P/N 3389

PART NAME				RIVET, SEMI-TUBULAR			
MATERIAL				BRASS			
FINISH		DUCTILE NICKEL PLATE		DRN BY	BOONE	DATE	8.26.82
				APP'D	RH	SCALE	5X
TOLERANCES		INCH [MM]		CODE		DWG NO.	
DECIMAL		± .005 [± 0.13]		C		3388 - 3391	
ANGULAR		± 1°		UNLESS OTHERWISE SPECIFIED

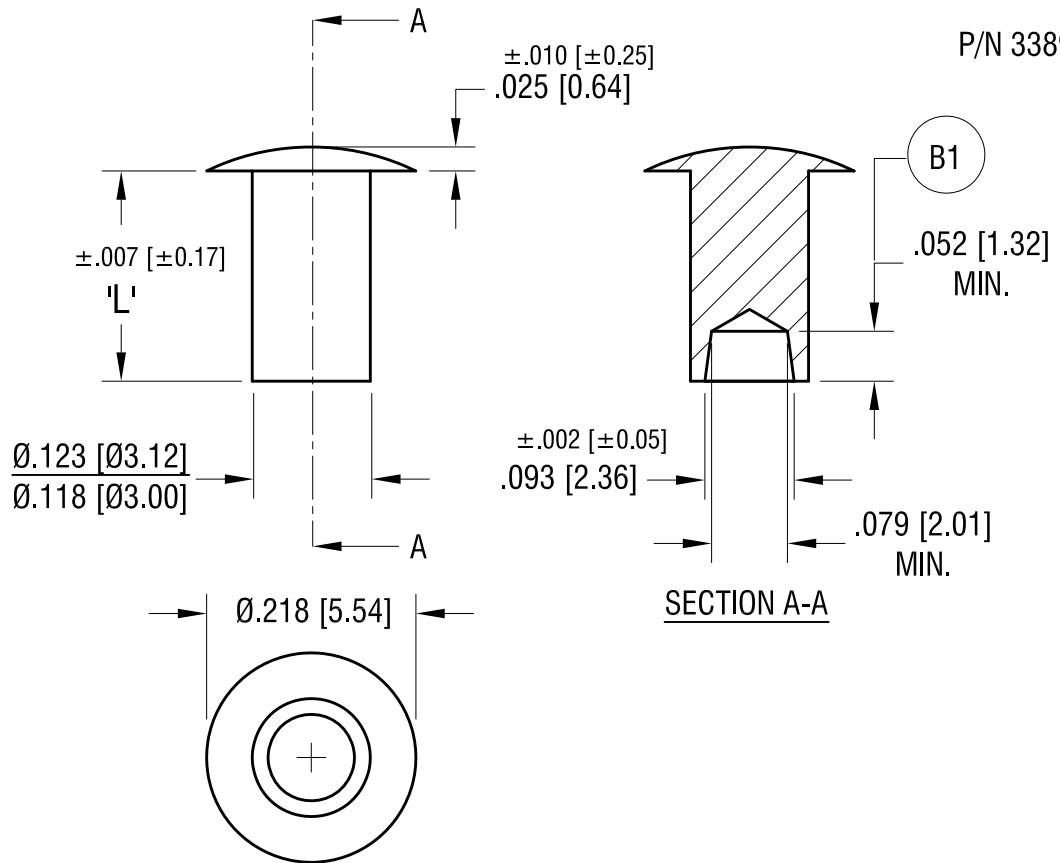
1.30.24	SWAGE HOLE IS TAPPED, WAS STANDARD B1 WAS .062±.010 CHANGE AS PER PCN 24-011	B
2.25.08	CHANGE AS PER ECN 08-090	A
DATE	DESCRIPTION	REV.
